APPLICATION NO.	FILING DATE	FIRST NAMED INVENTOR	ATTORNEY DOCKET NO.	CONFIRMATION NO.
10/783,339	02/20/2004	Brian Smidt	10646.399US01	6914
7590	10/03/2006		EXAMINER	
Merchant & Gould P.C. P.O. Box 2903 Minneapolis, MN 55402-0903				PAHNG, JASON Y
		ART UNIT		PAPER NUMBER
		3725

Advisory Action Before the Filing of an Appeal Brief	Application No.	Applicant(s)
	10/783,339	SMIDT ET AL.
	Examiner	Art Unit
	Jason Y. Pahng	3725

THE REPLY FILED 25 August 2006 FAILS TO PLACE THIS APPLICATION IN CONDITION FOR ALLOWANCE.

Figure A. Anvil including a Wedge-Shaped Portion and a Rectangular Portion

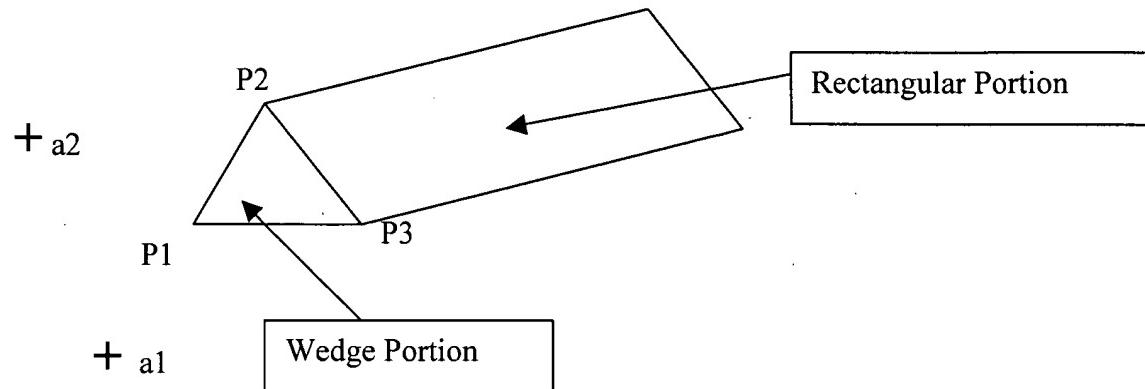
With regard to the Zehr reference, Applicant argues that Zehr does not disclose a rectangular portion and a wedge-shaped portion (page 6). However, Zehr discloses bars with triangular cross sectional shape. Therefore, Zehr discloses a rectangular portion and a wedge-shaped portion as shown below in attached Figure A.

With regard to the Zehr reference, Applicant also argues that Zehr does not disclose a second reference point being located farther from the axis of rotation than the first reference point (page 6). This is not true. See Figure A. If axis, a1, is chosen, then the second reference point further than the first reference point, P1, is either P2 or P3. If axis, a2, is chosen then the second reference point further than the first reference point, P1, is also either P2 or P3.
